## FIELD OBSERVATION REPORT

Central Hardin High School – Phase 2, Cecilia, KY

2019111 - CA8

Report No: 12

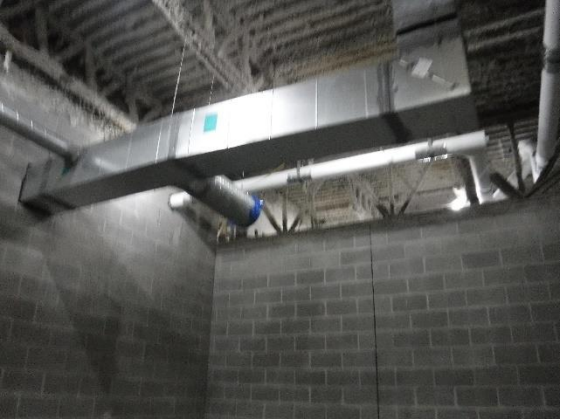
Item No.	Location	Description/Correction	Image	Action
1	East Side of Exterior of Area D	The added parapet was in place for the new roof.		Follow details for the completion of the parapet.
2	Area D North Elevation	The area is enclosed with permanent and temporary doors. The added parapet was in place for the new roof.		The parapet will be covered with metal panels. Phase 1 sheet metal work is nearing completion, workers will be available to begin on Phase 2.
3	Band Room	Metal framing was in place for wallboard soffits and at the columns.		Hang wallboard when all utilities are installed in the framing.

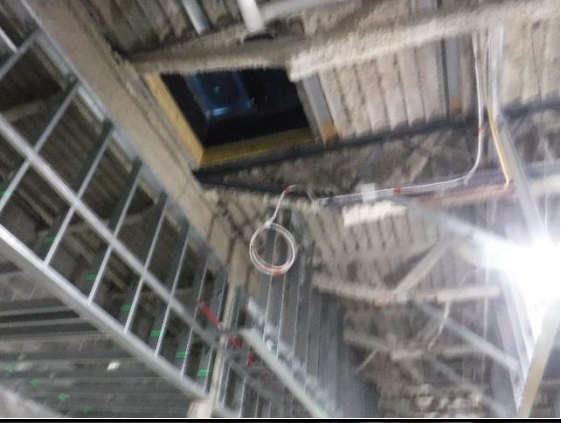
Item No.	Location	Description/ Correction	Image	Action
4	Area D East Corridor	Block fill was applied to the walls.		Inspect block walls for defects and correct before applying paint.
5	Area D Group Toilets	Ductwork was being installed. It appeared that fire dampers were installed where required.		Install fire dampers in fire rated walls where required.
6	Area D Gym Lobby	The metal framing was in place for the wallboard soffits.		Complete utilities above framing and hang wallboard.
